Revised Environmental Assessment and "Nationwide" Programmatic Section 4(f) Evaluations

Middle Fork Flathead River - SE Essex

BR 1-2 (85) 180

for
Middle Fork Flathead River - SE Essex
BR 1-2 (85) 180; Control No. 1763
Flathead County, Montana

Figure 3
Photo Simulation #2

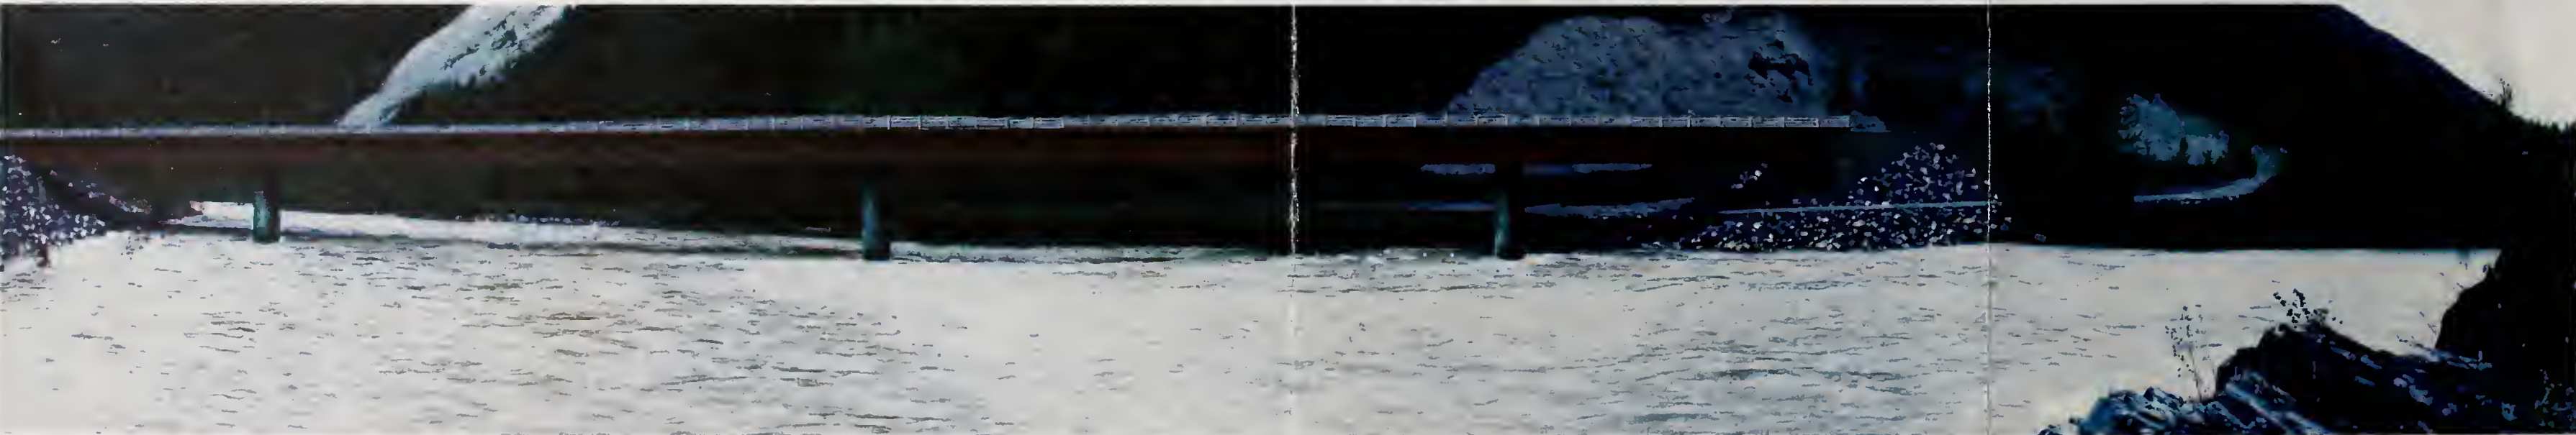
Figure 3 (page 21) of EA shows a long new access road being proposed across the entire affected landscape (in conjunction with 460 foot long new massive walls of riprap) that would "encroach slightly on the channel and require the placement of material in or near the river channel" including filling in two wetlands which are jurisdictional contrary to cursory excuses (p. 34-35).

The existing and probable future foreground visual landscape for river users is depicted with reasonable accuracy in Figure 3 (Photo Simulation #2). Readers were referred back to this Figure on page 51 of the EA. The visual landscape for those in rafts floating beneath the bridge would be dominated by views of the bridge, structural members beneath the bridge deck, and its piers. The new bridge would require one less pier in the river channel than the present structure. The riprap bank protection, access road to the dispersed recreation site, and the gabion retaining wall would also be seen from the river. The text of the EA will be modified to include a discussion of what river users would see.

The total length of the proposed access road is about 597 feet based on its beginning at the edge of U.S. Highway 2 north of the new bridge to the point where the new section of access road would join the existing access road. The proposed centerline of the access road segment is shown on Figure 2A (page 17) and its approximate length could be scaled from the drawing. Text on page 20 describes in narrative fashion where the access road would be located.
